MANDATORY BULLETIN

MB No: L23/060a Revision 2

Concerns: All L 23 SUPER-BLANÍK.

Subject: Inspection check of controls cable attachment screws and rudder hinge bolt

Fig. A

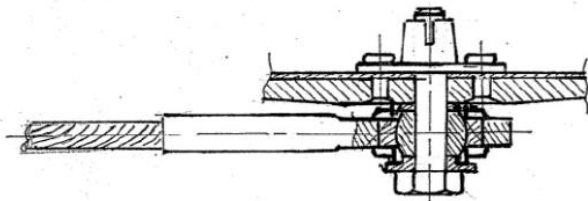
A.1 DISMOUNT (up to 79th series including – Fig.A)

1. Dismount the rudder according to the maintenance manual. (page 402-404, 27-20-00)
2. Place the rudder on the supports to allow good access to the cable attachment screws P/N A730515N and P/N A740259N, and rudder hinge bolt P/N A730514N - pos.21 (2x) pos. 22 on figure 1, page 3, 27-20-00 of the maintenance manual).
3. Clean and degrease the screws and hinge bolt.
4. Perform the penetrant testing on the entire accessible shoulder, thread undercut and thread of the screws and hinge bolt according to specification ASTM E1417-16, TYPE II, METHOD C, FORM e. The penetrant test must be performed by an approved organization.
5. Acceptance criteria: No cracks in checked area.

6. In case of passing the test – provide a record in the Airframe Logbook according to the part G of this bulletin. The operation of sailplane is permitted.
7. If cracks have been detected on the checked area, the operation of sailplane is prohibited. Send to the sailplane TC holder:
 - Registration mark
 - Serial Number
 - Total flight hours
 - Number of starts by winch and aerotowSailplane TC holder will send you the service bulletin No. L23/061b in order to perform the replacement of damaged screws.
8. Install the rudder according to the maintenance manual (page 402-404, 27-20-00)

Fig. B

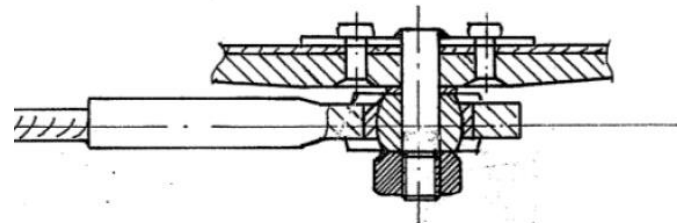
A.2 DISMOUNT (from 80th series – Fig. B)

1. Dismount the rudder according to the maintenance manual. (page 402-404, 27-20-00)
2. Place the rudder on the supports to allow good access to the cable attachment stud bolts P/N A730545N and P/N A730540N, and rudder hinge bolt P/N A730514N - pos.21 (2x) pos. 22 on figure 1, page 3, 27-20-00 of the maintenance manual).

3. Clean and degrease the stud bolts and hinge bolt. (Do not drill-out the stud bolts out of the rudder).
4. Perform the penetrant testing on the entire accessible shoulder, thread undercut and thread of the stud bolts and hinge bolt according to specification ASTM E1417-16, TYPE II, METHOD C, FORM e. The penetrant test must be performed by an approved organization.

5. Acceptance criteria: No cracks in checked area.
6. In case of passing the test – provide a record in the Airframe Logbook according to the part G of this bulletin. The operation of sailplane is permitted.

7. If cracks have been detected on the checked area, the operation of sailplane is prohibited. Send to the sailplane TC holder:
 - Registration mark
 - Serial Number

- Total flight hours
 - Number of starts by winch and aerotowSailplane TC holder will send you the service bulletin No. L23/061b in order to perform the replacement of damaged Stud bolts

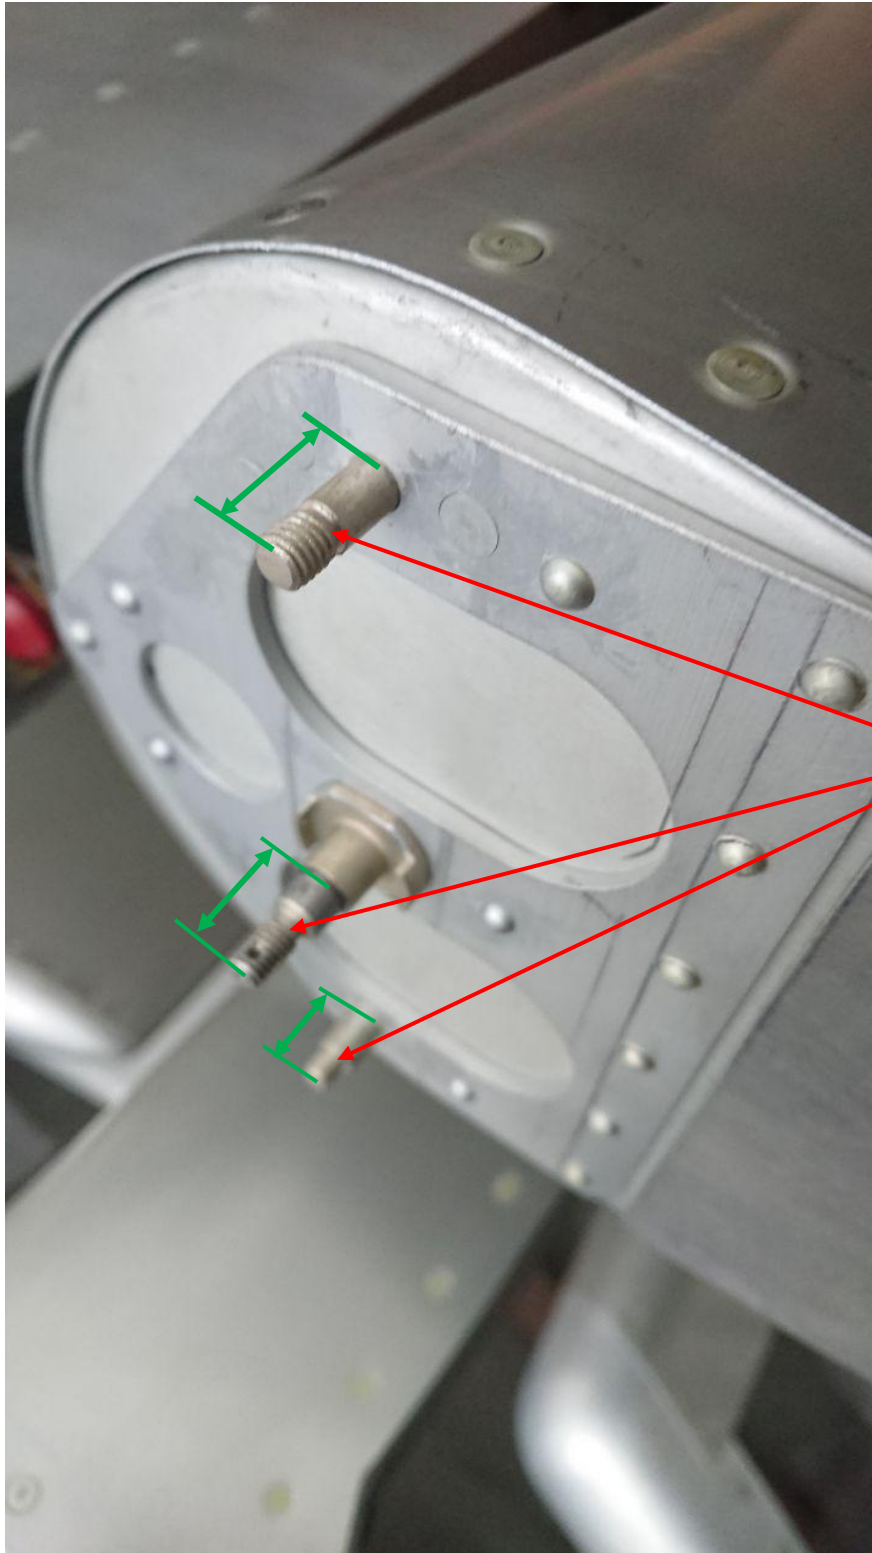
This seem to be the stud bolts and the hinge bolt from series 80 on.
